project:	Scarborough Health Network Mental Health Inpatient Consolidation Pod 3A3030 Birchmount Road, Scarborough, ON	ADD:	01
MMC RFQ#:	CW29854	date:	2026-06-24
HJA project no:	24-20	page 1 of:	10 + attachments

5.0 ARCHITECTURAL DRAWINGS

5.1 A-000 COVER

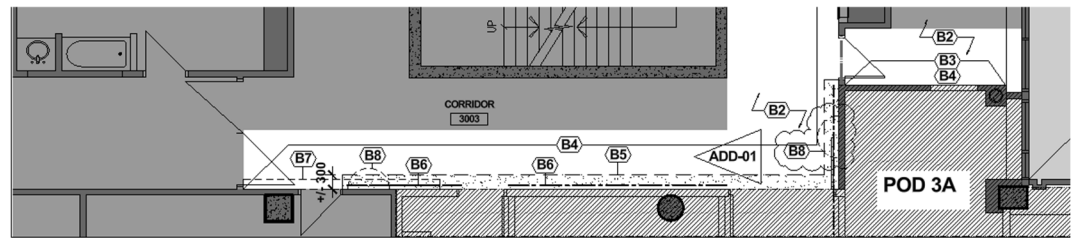
- .1 **ADDED A SHEET** – A new sheet is added to the Architectural Drawing List. See sketch below: -

A-700	MISCELLANEOUS DETAILS	
A-701	MISCELLANEOUS DETAILS	
A-702	MISCELLANEOUS DETAILS	ADD-01

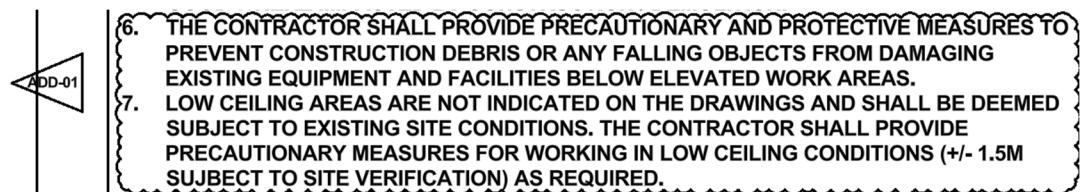
- .2 **CORRECTED TYPO** – Typo corrected in the title on drawing 03/A-003. See sketch below: -

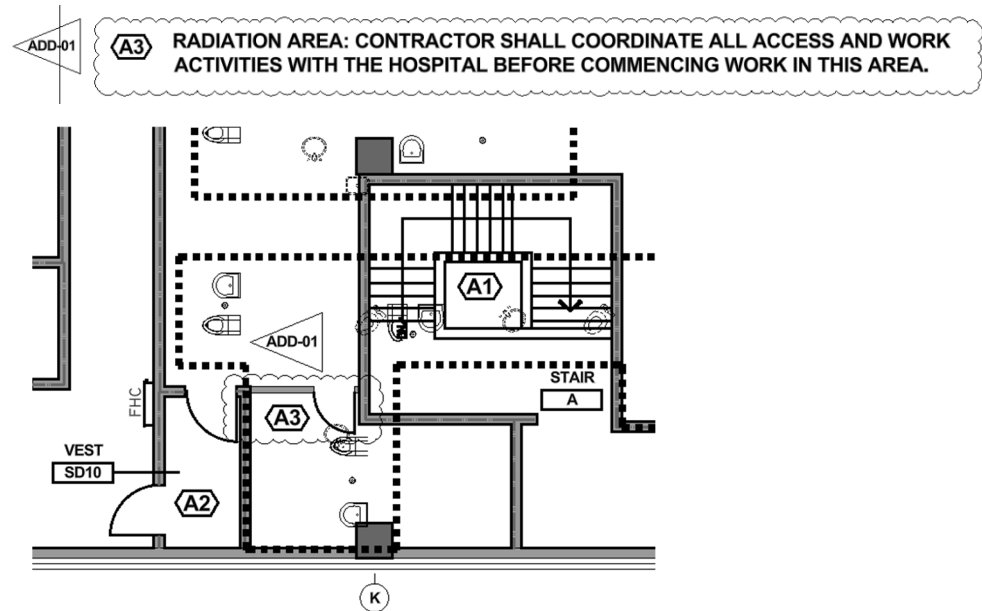
- .3 **NEW NOTE** – New general note 6 and 7 added to drawing 05/A-003. See sketch below: -

5.3 A-004 PARTITION ASSEMBLIES

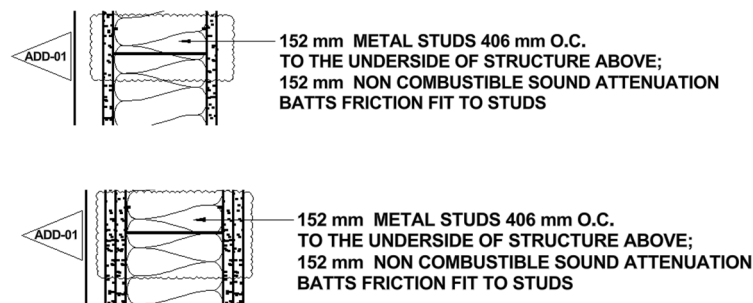
- .1 **REVISED GRAPHICS** – Metal stud is added to illustrative representation of partition type P8, P9, P10 and P11. See sketch below: -

5.9 A-501 GLAZED SCREEN SCHEFDULE & PATIENT ROOM DOOR VISION PANEL

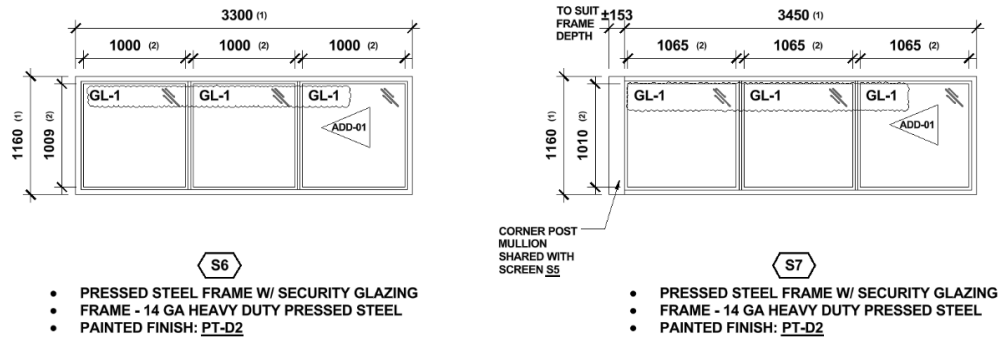
- .1 **NEW NOTE** – A new note, as described in the sketch below, added to drawing 10/A-501 & 11/A501.

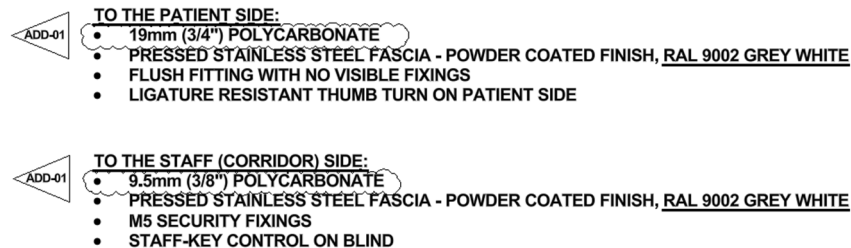
- .3 **REVISED GLAZING TAG** – Glazing type for Glazed Screen Type S6 and S7 changed from GL-8 to GL-1 on drawing 06-A501. See sketch below: -
